71-9314

27 February 2007

Docket No.: 71-9314 & TAC No: L24038

The following is provided in response to your letter dated 7 February 2007 requesting additional information to support our amendment request for this package design. Items are addressed in the same order as your letter:

FIGURE 1 Model 3018 General Assembly

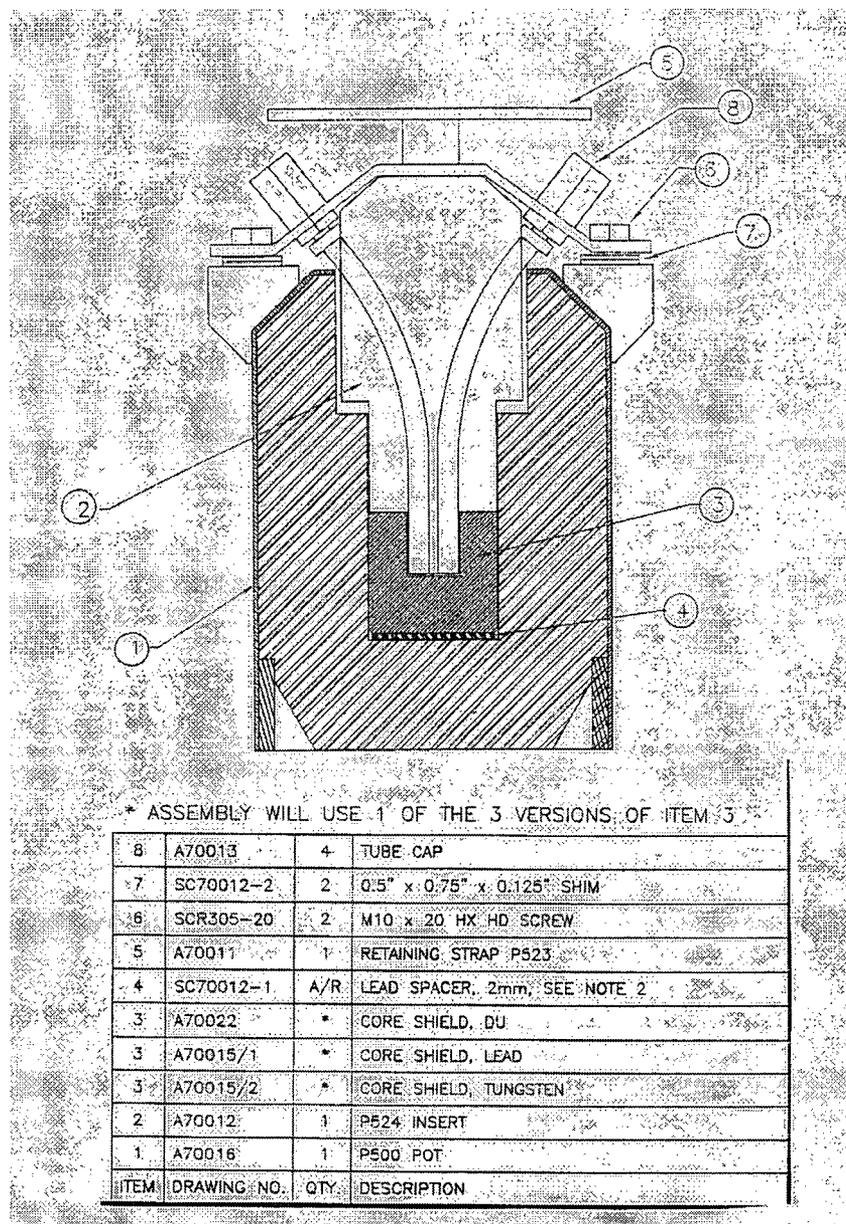
- 2-3 The addition of lead spacers between the 3018 core shield and the bottom of the lead pot (see Figure 1) was determined necessary based on observations from operation of the current design. It was shown that the allowable tolerances in manufacture produce combinations of components where the source tubes on 3018 insert P524 can interfere with the top corner of the pot P500. This interference can lead to distortion (crimping) of the tubes. While this is not a safety issue and has no impact during transportation, it can be avoided by placing one or two lead spacers in the base of the pot to raise the core shield and insert and eliminate the interference.

The addition of steel spacer is necessary between the retaining strap and the P500 pot at the two attachment points. This lifts the retaining strap to compensate for the rise of the insert due to the presence of the lead spacer(s). The nuts securing the retaining strap will therefore be able to be tightened squarely against the steel spacer, maintaining the alignment of the system securing the retaining strap to the P500 pot.

Safety is not reduced by these modification because the lead spacer inside the lead pot has a similar shielding configuration to the configuration previously evaluated/approved and the steel spacer maintains the ability of the package to meet all the transport requirements. The modification is primarily to include one or two lead spacers to improve operational issues and a steel spacer is also added to maintain the integrity of the method of securing the cover. The modification changes the packaging design but does not affecting the safety of the package in transport.
